Subj: CPT/HYDROPUNCH PROGRAM, REMEDIAL INVESTIGATION/FEASIBILITY
STUDY (RI/FS), PHASES 2B & 3, 5 & 6, NAVAL AIR STATION (NAS) ALAMEDA, CA

Subject: CPT/HydroPunch Program
Naval Air Station (NAS) Alameda, Alameda, California
CLEAN Contract No. N62474-88-D-5086, Contract Task Order No. 0280

Outlined below are suggested changes in the field effort currently being conducted at NAS Alameda under CTO No. 0280. These changes relate to eliminating and/or substituting future cone penetrometer test (CPT) and HydroPunch locations based on our review of recently obtained geotechnical data, as well as a review of the potential overlap of CPT/HydroPunch location coverage for adjacent IR sites that were covered under separate field sampling plans (FSPs).

Ph. -16 FSP
Fig. 3-1

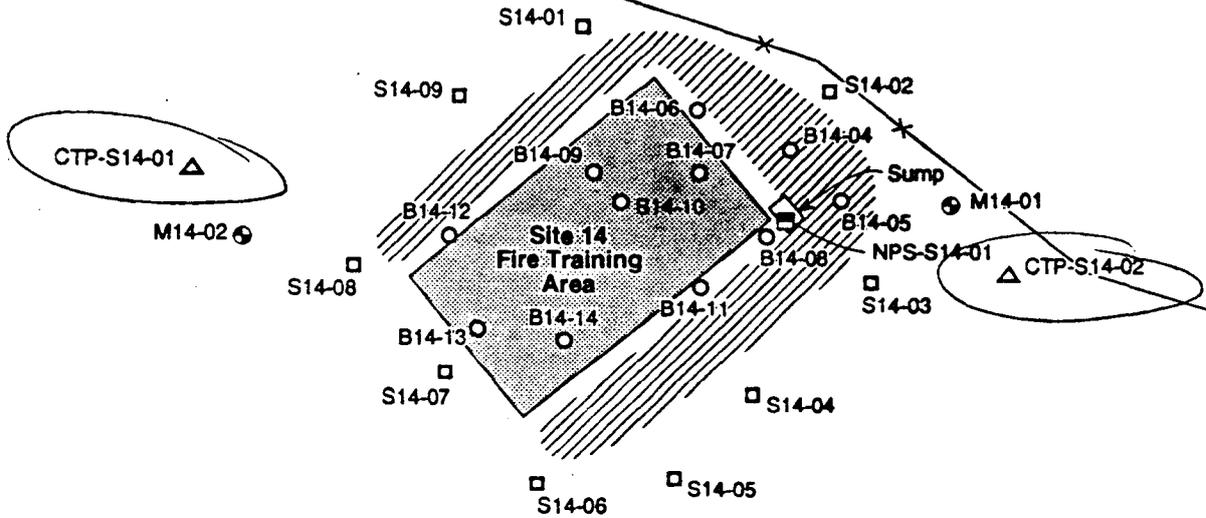
A total of three CPT and three HydroPunch locations are recommended for removal in the Runway Area and Site 1 (See Figure 3-1, Phases 5/6 Follow-On FSP; and Figure 11-1, Phases 2B/3 Follow-On FSP).

CPTRA-1 is located at Site 14, where three CPT/HydroPunches and one deep well have already been advanced. The proposed CPT/HydroPunch is located approximately midway between CPTS14-01 and CPTS14-02. It is suggested that existing data are sufficient enough to remove proposed CPTRA-1 and the proposed HydroPunch.

CPT-1-9 is located adjacent to existing well cluster M027-A/E/B/C, which is screened at four locations (two in the upper water bearing zone and two in the lower water bearing zone). The well was continuously logged, and extends to the top of the Yerba Buena mud, providing deep lithologic data. Also, the wells are screened at four different locations, which provide shallow groundwater quality as well as deep groundwater quality. It is suggested that existing data are sufficient enough to remove proposed CPT-1-9 and the proposed HydroPunch.

CPT-1-3 is located adjacent to existing well cluster M025A/E/C, which is screened at three locations (two in the upper water bearing zone and one in the lower water bearing zone). The well was continuously logged, and extends to the top of the Yerba Buena mud, which provides deep, lithologic data. It is suggested that existing data are sufficient enough to remove proposed CPT-1-3 and the proposed HydroPunch.

Ph. 2A FSP Fig. 7-1

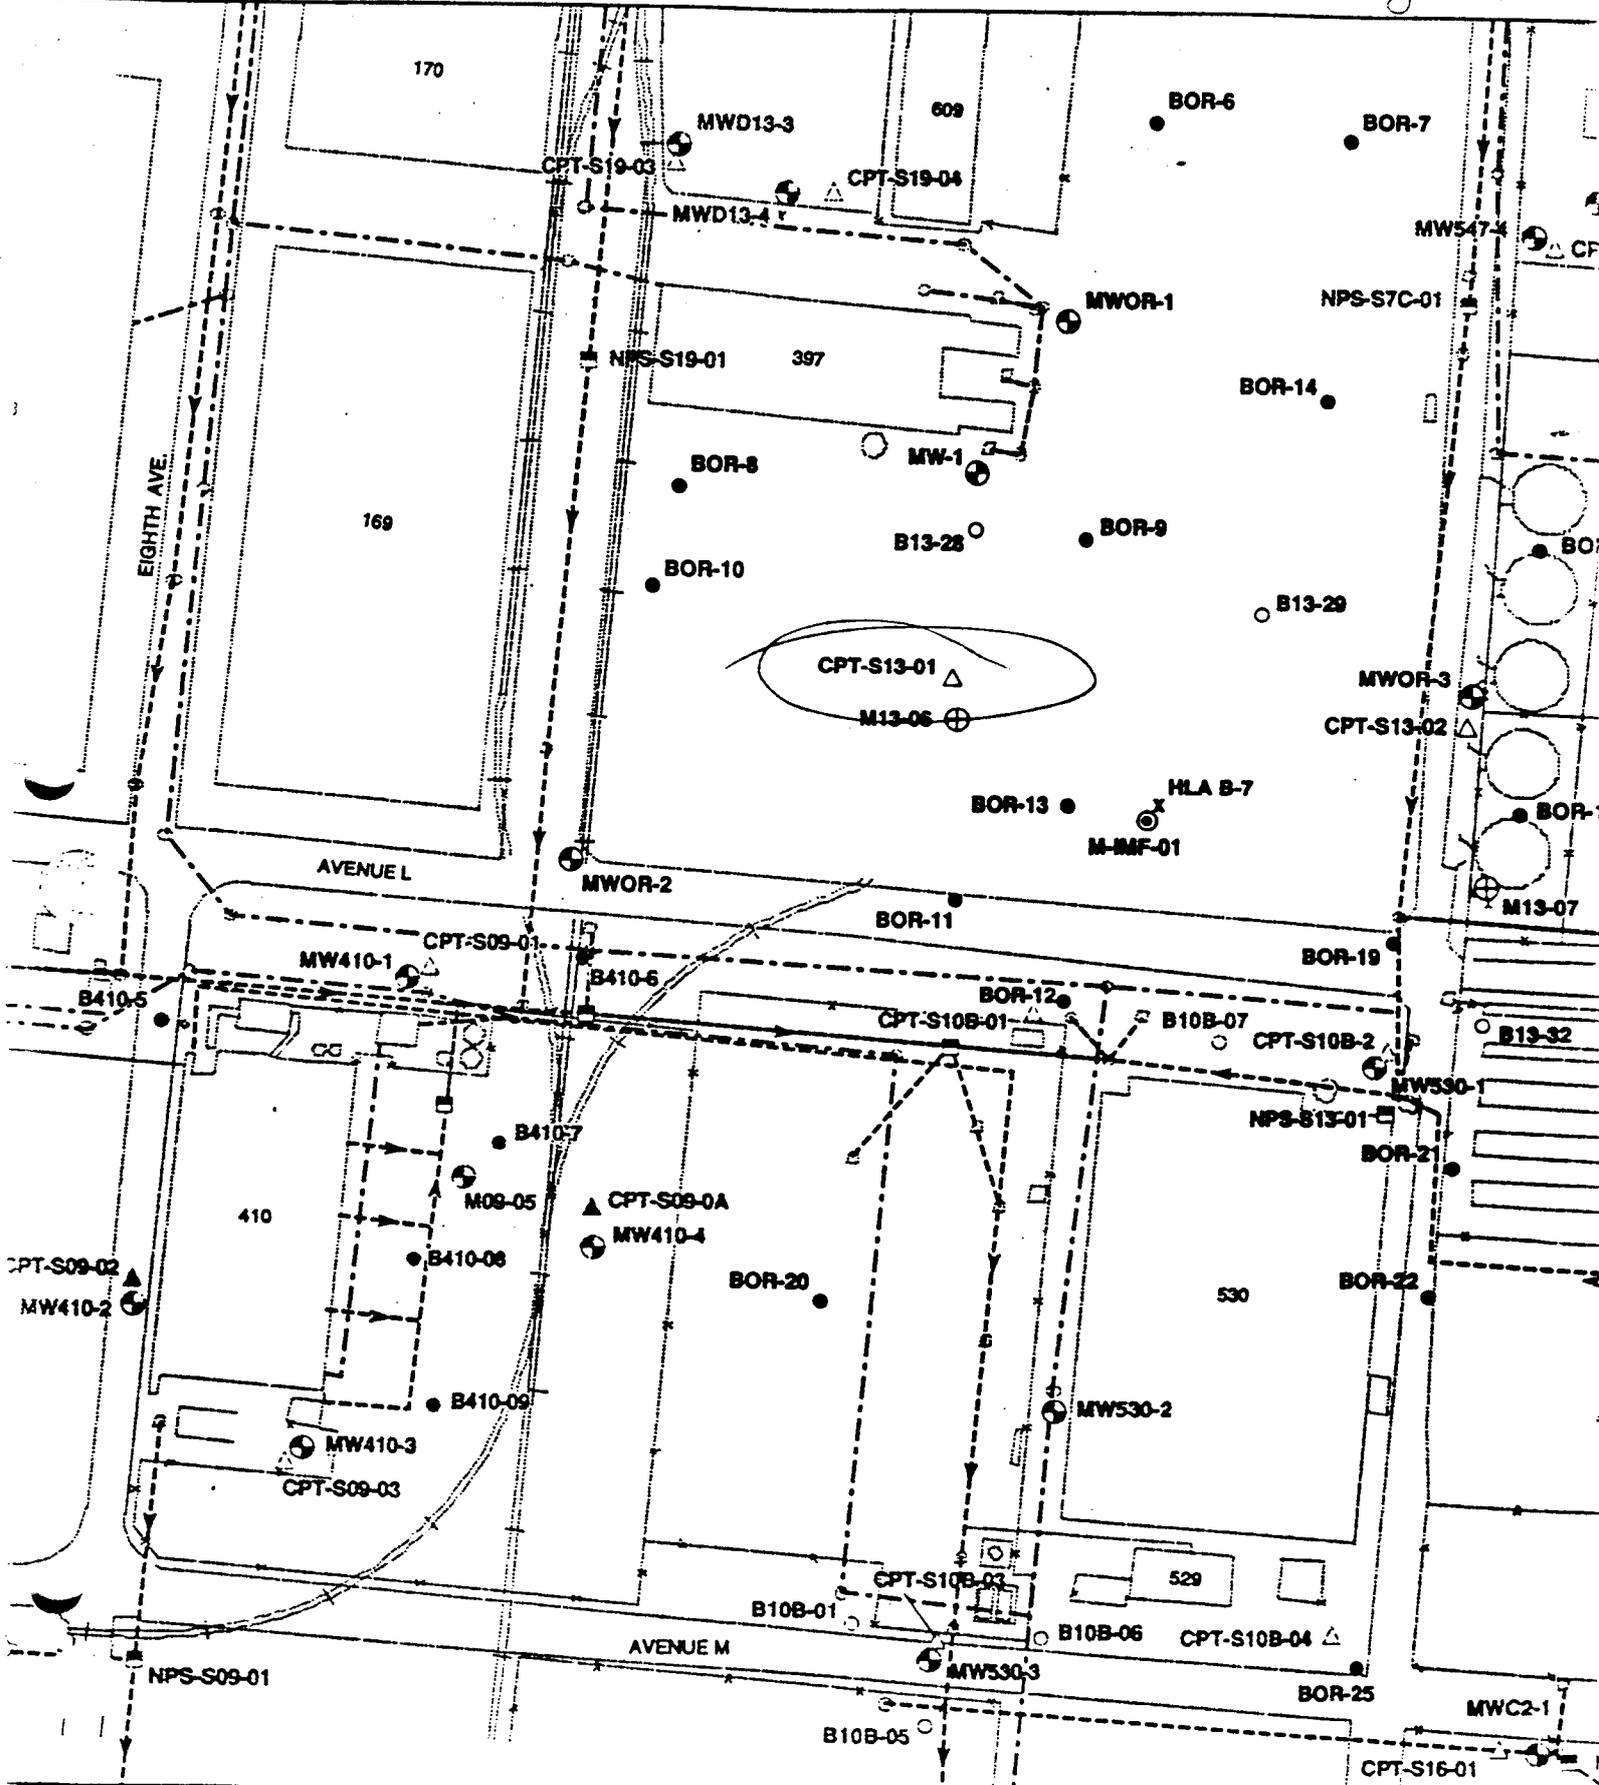
One CPT location is recommended for removal at Site 13 (Figure 7-1, Phase 2A Follow-On FSP).

CPT-S13-01 is located adjacent to geotechnical boring 1DK-HLA-1. The geotechnical boring extends to 50 feet (the maximum CPT depth) and identifies a homogenous, well-sorted sand from 10 feet bgs to the bottom of the boring. This coincides well with the conceptual model of outcropping Merritt sand in the southeast corner of the base. It is suggested that existing data are sufficient enough to remove proposed CPT-S13-01, but retain the HydroPunch groundwater sample. Additionally, numerous shallow CPT/SCAPS penetrations were advanced in this area (to 20 feet bgs) in March/April 1994, providing good subsurface control to that depth.

NAVAL AIR STATION ALAMEDA
 ALAMEDA, CALIFORNIA
SITE 15
PROPOSED SAMPLE LOCATIONS
 FIGURE 12-1

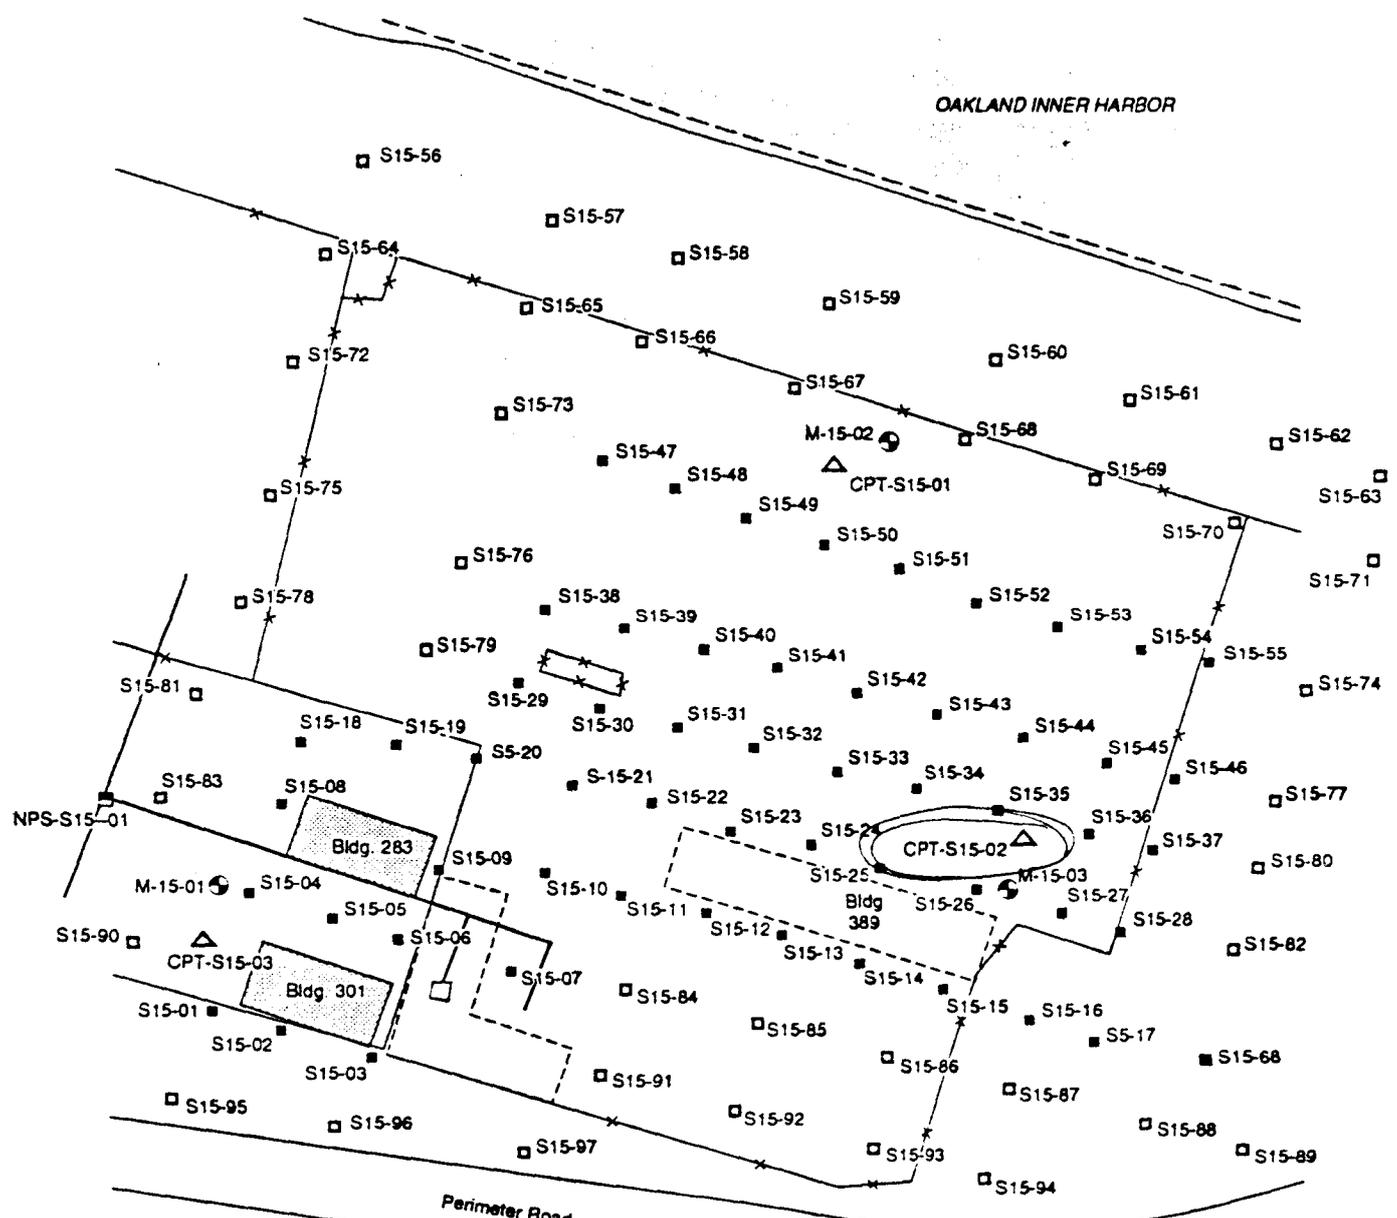
One CPT location and one HydroPunch location are recommended for removal at Site 15 (Figure 12-1, Phases 2B/3 Follow-On FSP; Figure 3-1, Phases 5/6 Follow-On FSP).

Three CPT/HydroPunch locations are scheduled for Site 15; however, one of the CPT/HydroPunch locations which is proposed for characterization of the lithology in the Runway Area is located adjacent to a Site 15 CPT/HydroPunch. It appears that the data to be provided by CPT-RA-6 will be sufficient to use in lieu of CPT-S15-02, therefore it is suggested that the CPT-15-02 location be removed from the field program.
